**STAFF REPORT:** 2/23/2022 MEETING  
**APPLICATION NUMBER:** #22-7661  
**ADDRESS:** 1052 SEMINOLE  
**HISTORIC DISTRICT:** INDIAN VILLAGE  
**APPLICANT:** PHILLIP COOLEY  
**ARCHITECT:** CHRISTIAN HURTTIENNE ARCHITECTS  
**PROPERTY OWNER:** PHILLIP COOLEY  
**DATE OF PROVISIONALLY COMPLETE APPLICATION:** 1/18/2022  
**DATE OF STAFF SITE VISIT:** 1/25/2022

**SCOPE:** ERECT A REAR ADDITION

# COOLEY RESIDENCE ADDITION

*Northeast and Northwest Elevations by Applicant showing rear proposed addition, windows, doors, porches and steps.*

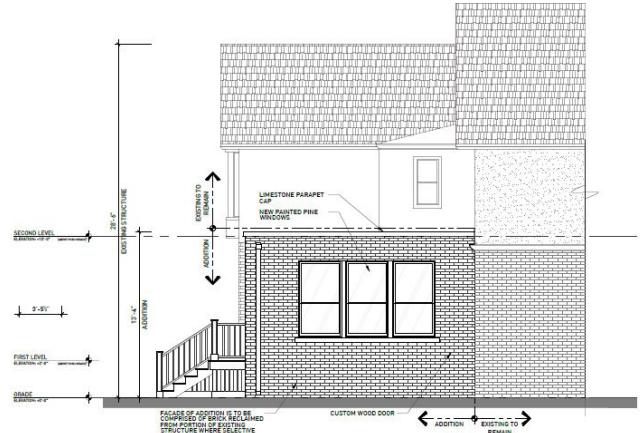
- Provided a roofing membrane specification (see attached).
- The proposed elevation drawings show the existing configuration of the rear windows of the first and second story as 6/1, are actually 9/1 configuration. The middle, second-story window of the protruding area is also 9/1, not 1/1 configuration. Staff also observed that the label on the side elevation “custom wood door” points to a proposed wall.

- The applicant provides HDC staff a dimensional elevation drawing showing locations of the exterior lights, doors and windows, and cut sheets on the sliding doors for HDC staff review and approval. Should the proposed design products and materials not be acceptable to staff, they will be returned to the Commission for further review.
- Selection of replacement bricks shall be reviewed by staff for compatibility. Replacement brick shall be field mixed with salvaged brick to create a uniform expression.

**4 ARCHITECTURE PLAN**  
ORIGINAL DRAWING SCALE: 1/4" = 1'-0"

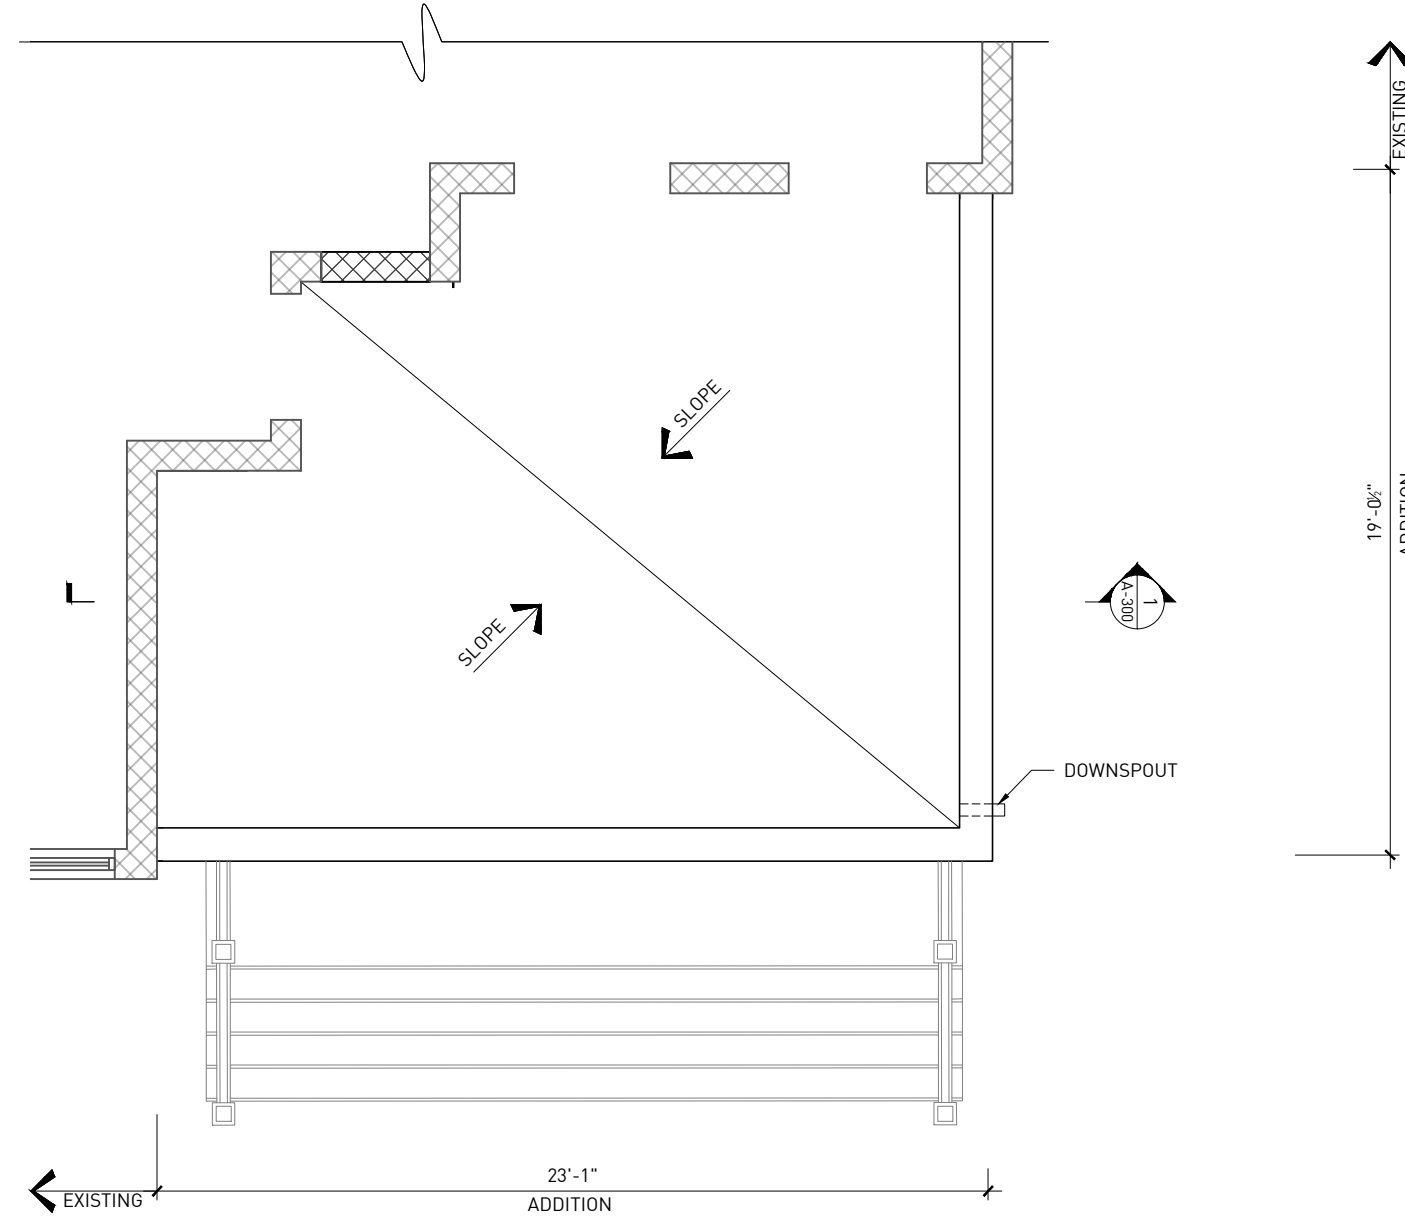
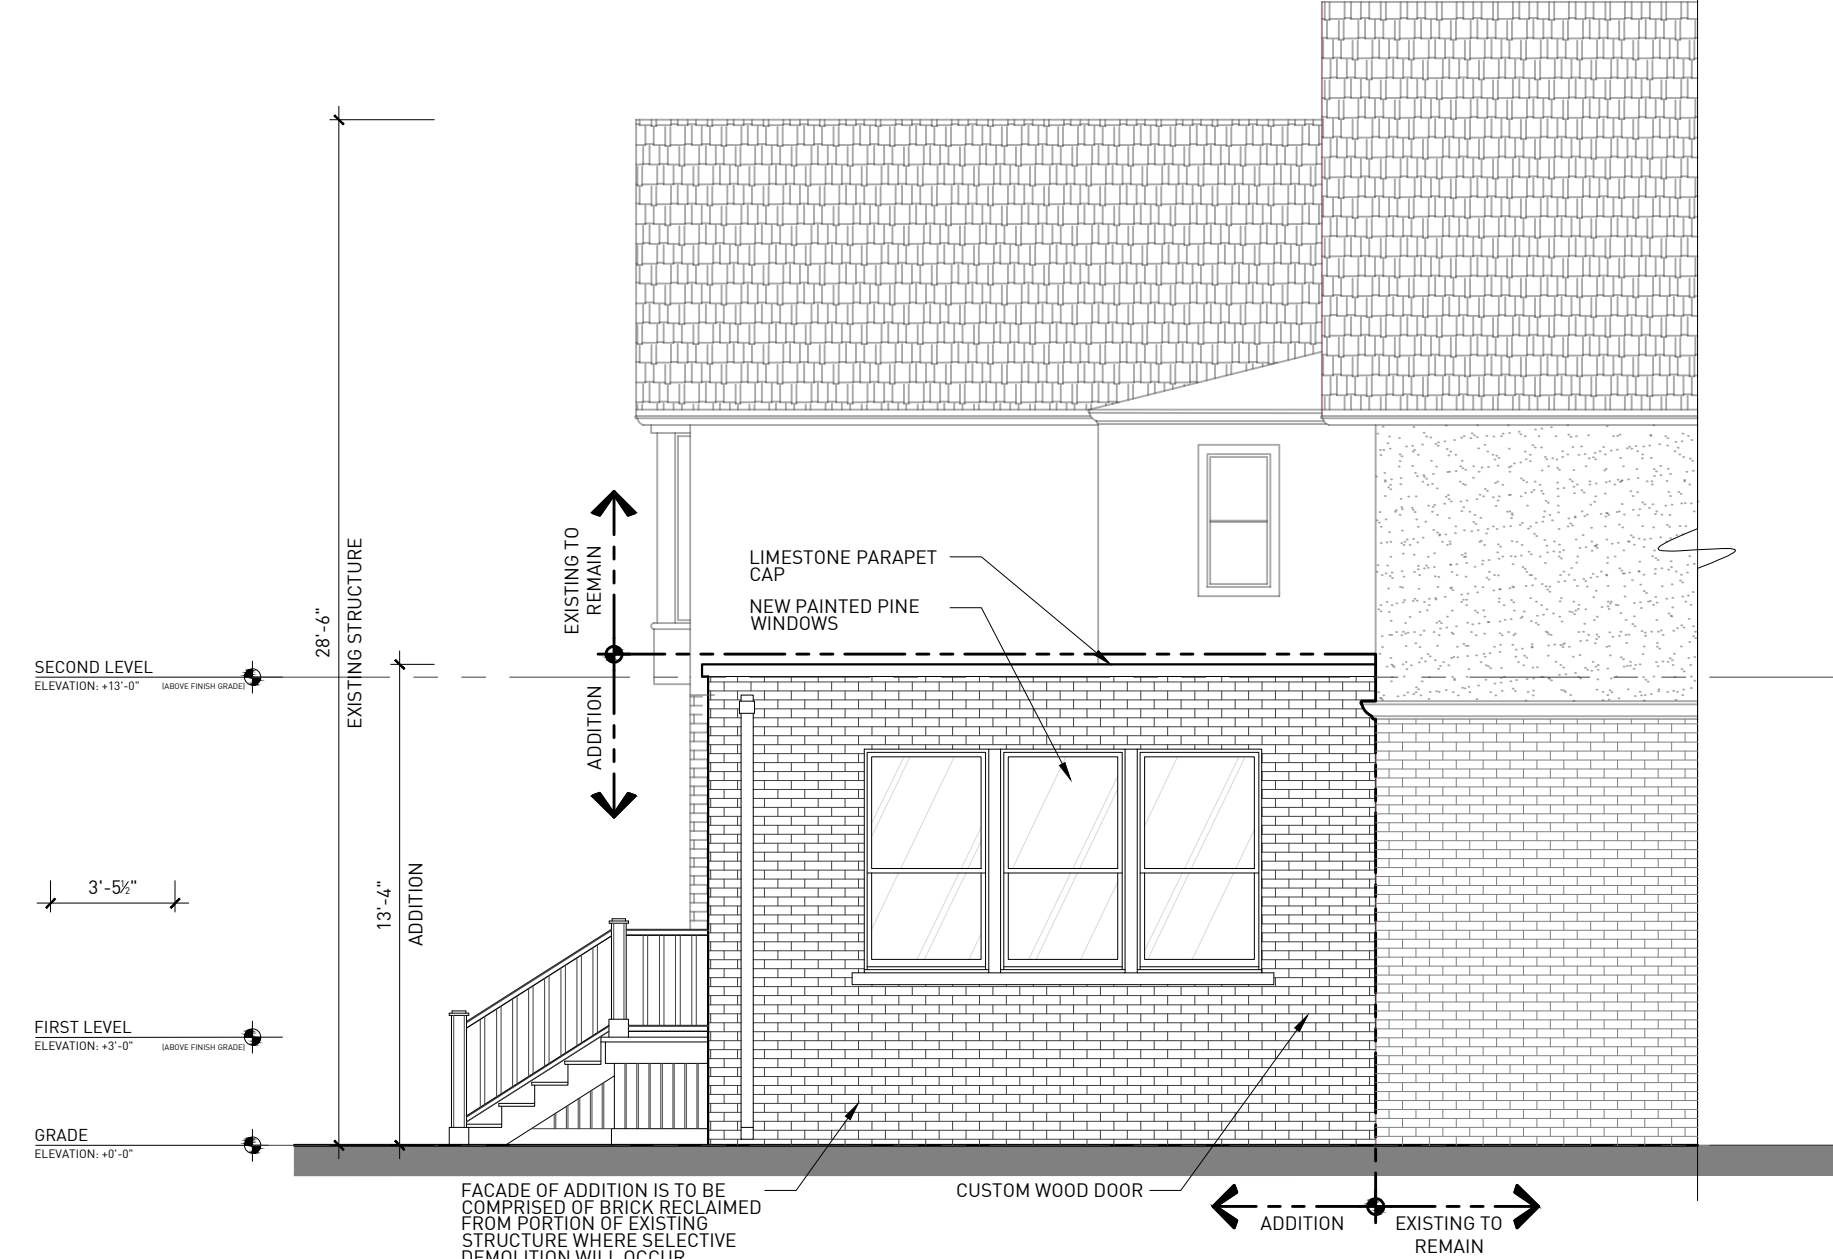
1. What is the materiality of the mullions between the windows? I see that they're 4" wide, but I don't see a description of what they will be.
2. Can you describe it the mullions will be fabricated on site or pre-fabricated and the whole opening of all the windows are installed as a unit?
3. What is the finish and color of the mullions?

1. Now that there is no longer a side door, please confirm the count and locations for the exterior lights.
2. What is the color and finish of the deck and its steps?
3. Please provide cut sheet on the sliding glass doors that show the material, dimensions, operation, color and finish. Are there muntins as shown in the drawings? Please provide details on the muntins (or are these between the glass grills?).

The windows are made by Pella and they are a prefabricated unit. They are wood windows and are aluminum clad. They will be the same dark brown to match the windows we've installed already made by Pella. When there is trim needed, such as a mullion, we will be using Mahogany and painting it that Sherwin Williams seal skin color that matches the windows and the rest of the trim on the house. Each window unit will be installed onsite and trimmed onsite afterward.

1. No side door. Just one light to the right of the single door.
2. Cedar deck. Clear coat.
3. Working on this.

DRAWING NO. **A-300**

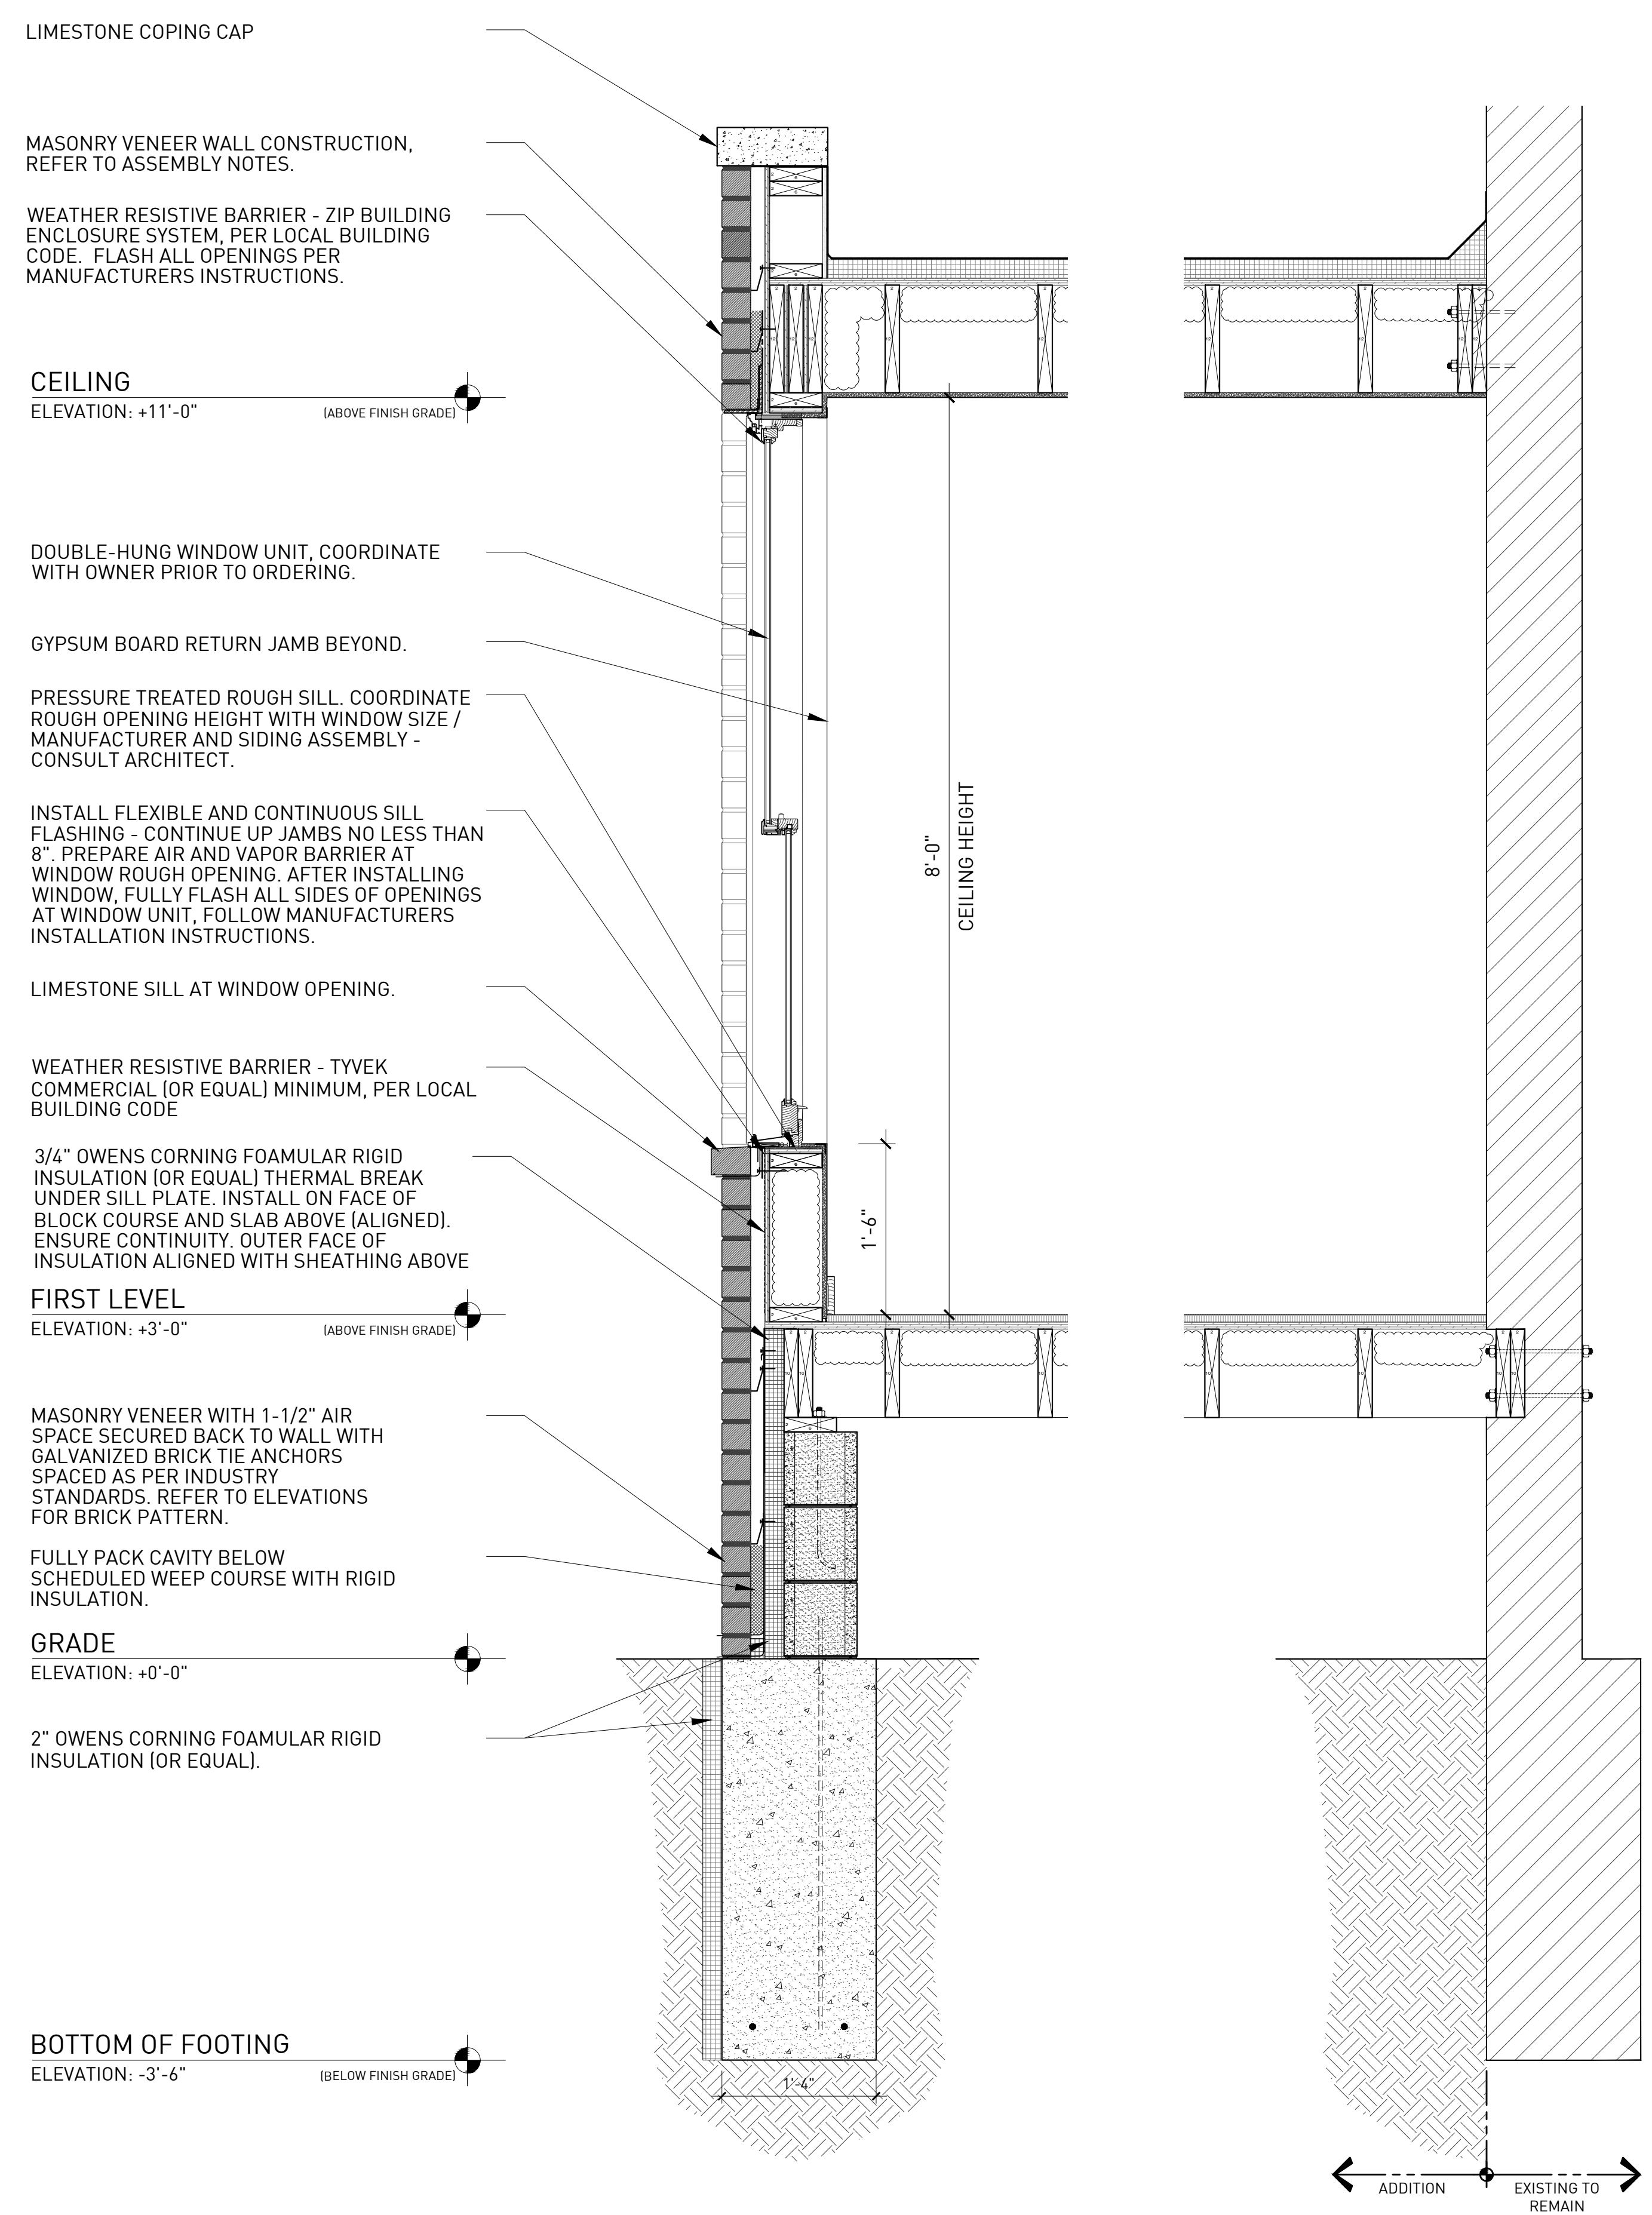
- Staff observed that the dimensions of the proposed windows in section on Sheet A-300 are missing, but they appear to be approximately 6’ 3” tall and have a limestone sill at the window opening.
